ACCESSION NBR: 8310210024 DOC. DATE: 83/10/14 NOTARIZED: NO DOCKET #
 FACIL: 50-400 Shearon Harris Nuclear Power Plant, Unit 1, Carolina 05000400
 50-401 Shearon Harris Nuclear Power Plant, Unit 2, Carolina 05000401

SUBJECT: *see rpt* Forwards responses to requests for addl info re draft SER open items.

SHEARON HARRIS NUCLEAR POWER PLANT
UNIT NOS. 1 AND 2
DOCKET NOS. 50-400 AND 50-401
RESPONSES TO REQUESTS FOR ADDITIONAL INFORMATION

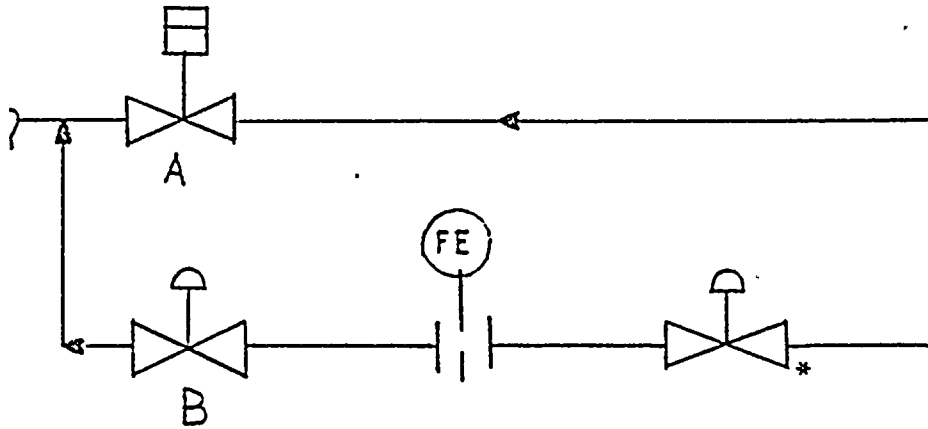
Note #1: The arrangement should be shown as detail "c" "Typical Bypass at Feedwater Isolation Valve" of FSA2 Figure 10.1.0-3 (See insert 1)
